NUMBER: S.I. M20-63  
DATE: 4-12-83

**SUBJECT:** ENGAGEMENT OF BAGGAGE DOOR AUXILIARY EXIT LATCHING MECHANISM.

**MODELS/SERIAL NUMBERS AFFECTED:** Mooney M20J S/N 24-0084, 24-0378 through 24-1381. Mooney M20K S/N 25-0001 through 25-0754.

FIGURE 1

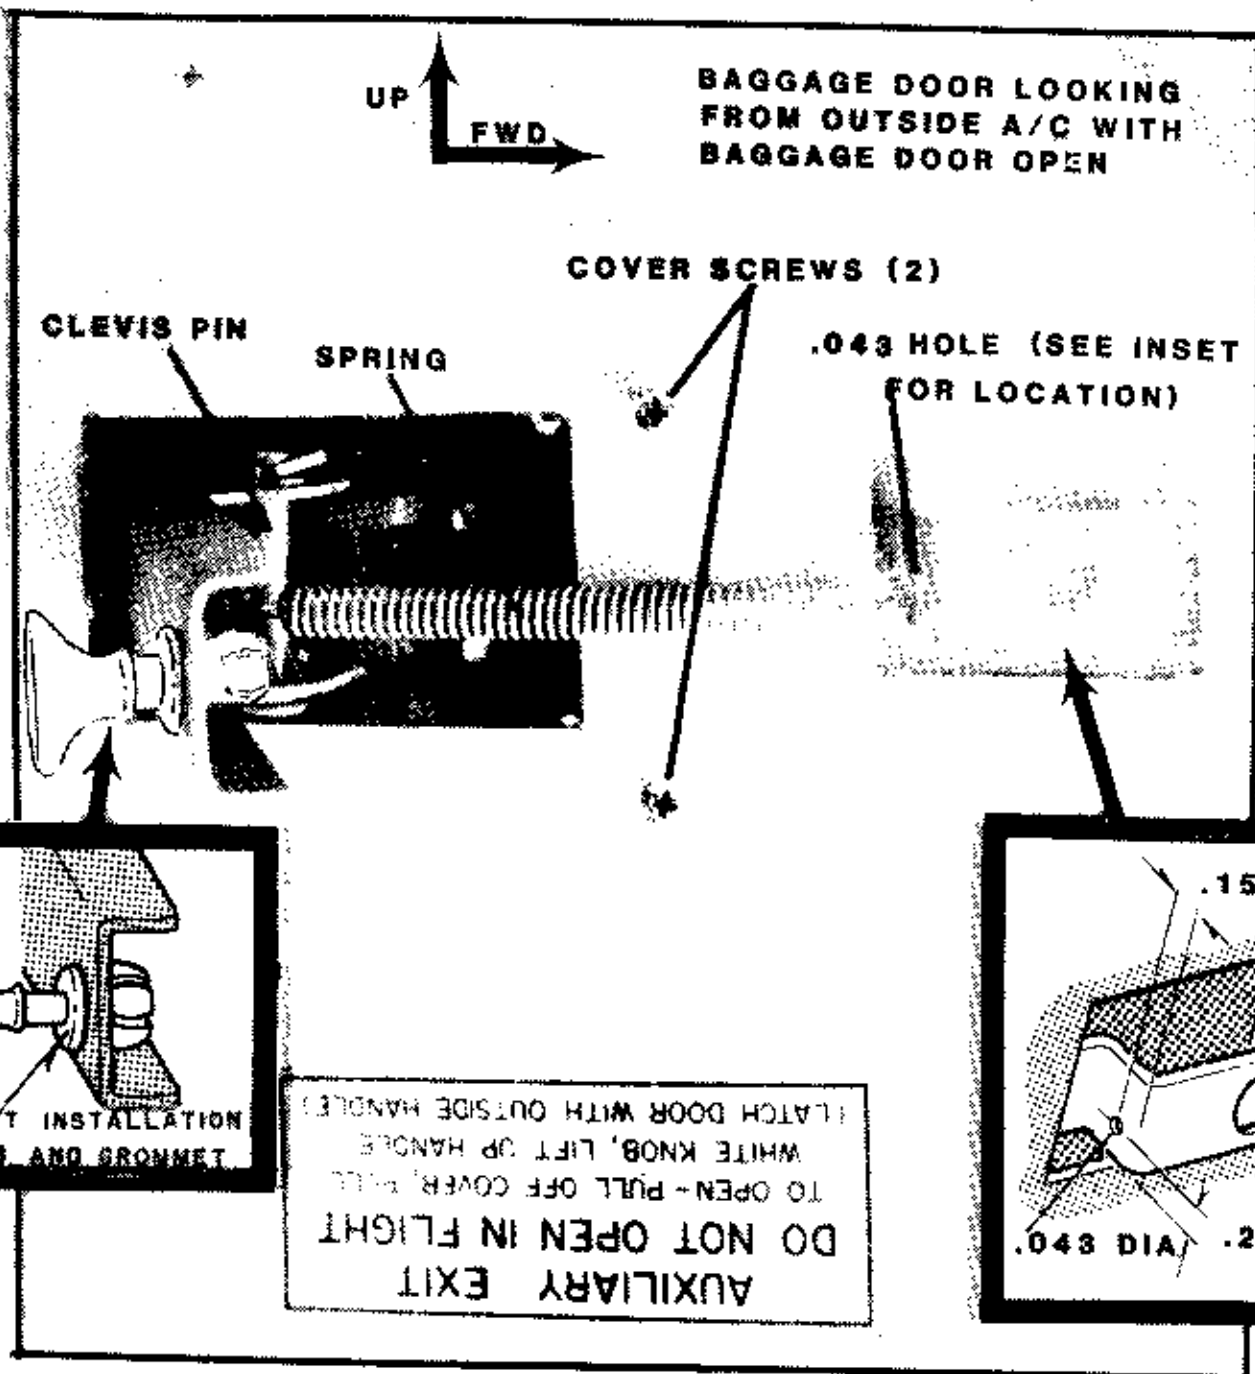
3. Check white plastic (nylon) knob and grommet to verify correct installation. (See figure 1).
4. Pull red handle fully open; mark, center punch and drill a .043 dia. hole in the clip, P/N 350191-5, (see figure 1 insert for location).

5. Attach LE-029C-6 spring to clip at new hole.
6. Attach other end of spring to 350190-1 new clevis pin which engages into cam slot of outside handle assembly.  
NOTE: The existing AN393-35 clevis pin will require removal from handle assembly to allow the new pin to be used. (see figure 1).
